## ADDENDUM 1

**PROJECT:** 12-22-001 Scoreboards Bid

**ADD THE FOLLOWING SPECIFICATIONS TO THE SCOPE OF WORK.** Full size pages of these images below are provided with this addendum.

# <u>Data Switch Enclosure</u> (Inside Wall, South-East Corner, Above Lockers)

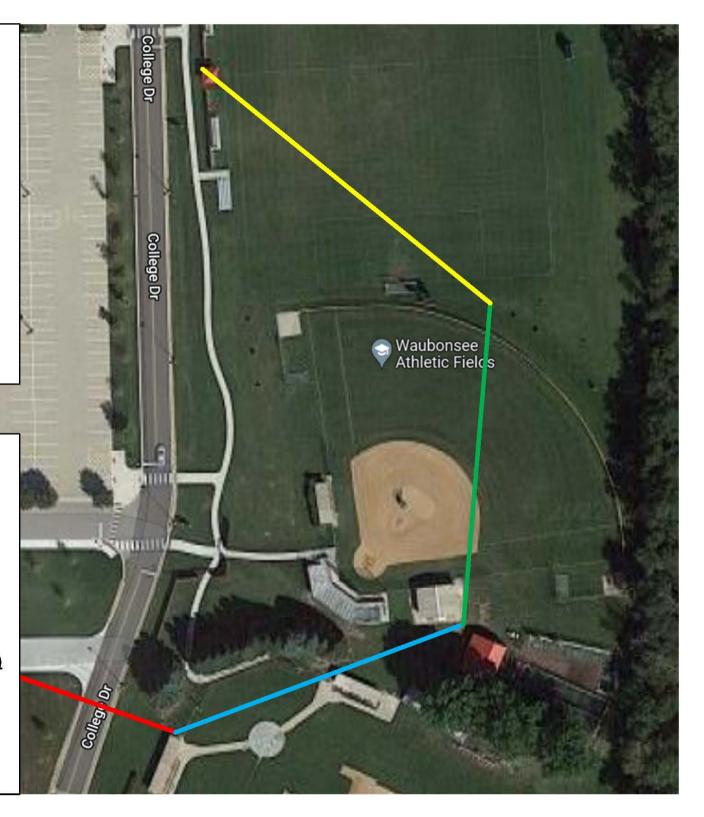
- Installation of Data Switch Enclosure
  - -- Inside Wall, South-East Corner, Above Lockers
  - -- The following items to be provided by installer
  - --- HSQ24S26 Enclosure: Solid, 24"H, 26"D, 22.6"W,

- --- HWKF120 Fan kit and tray, 120V)
  - --- FSPNLCDS6Y Fiber Optic Panel Adapter, 12-Fiber, 6 LC Duplex, Zircon Sleeves, Yellow)
  - --- FCR1U3SP FCR Series Fiber Optic Rack Mount Enclosure, 1U, 3 FSP Panel, Unloaded)

HSQ24S26 (Enclosure: Solid, 24"H, 26"D, 22.6"W,

HWKF120 (Fan kit and tray, 120V)

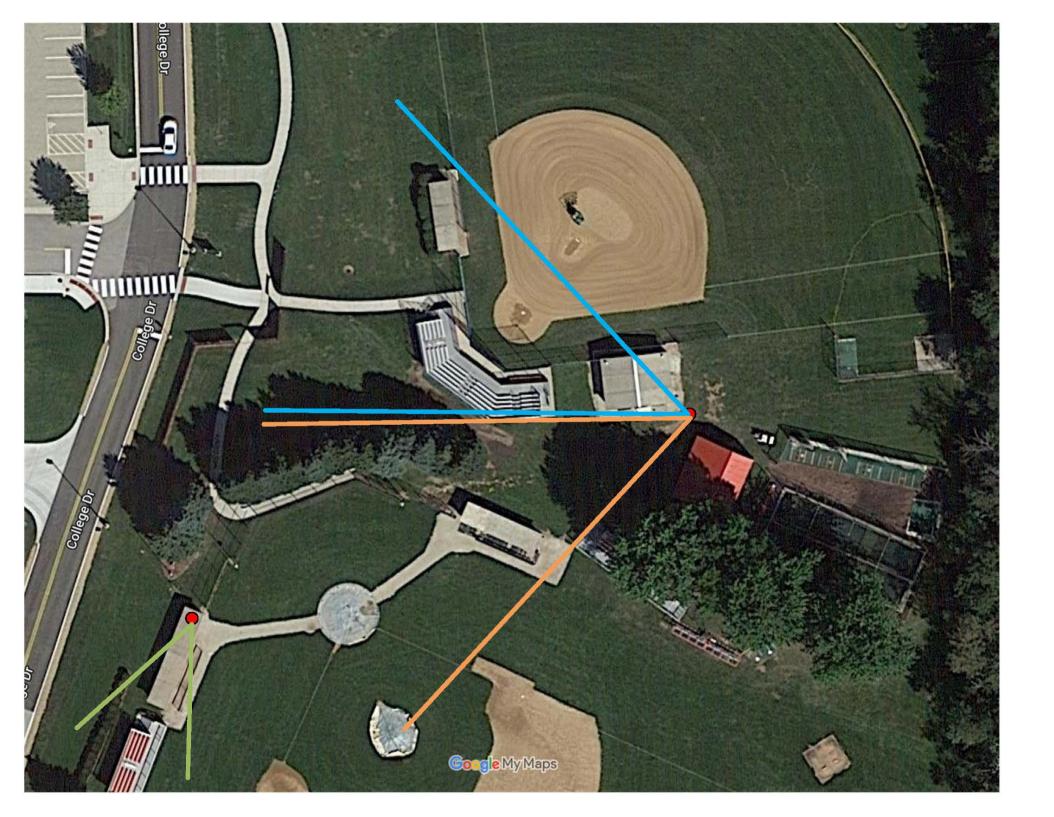
FSPNLCDS6Y (Fiber Optic Panel Adapter, 12-Fiber, 6 LC Duplex, Zircon Sleeves, Yellow)
FCR1U3SP (FCR Series Fiber Optic Rack Mount Enclosure, 1U, 3 FSP Panel, Unloaded)
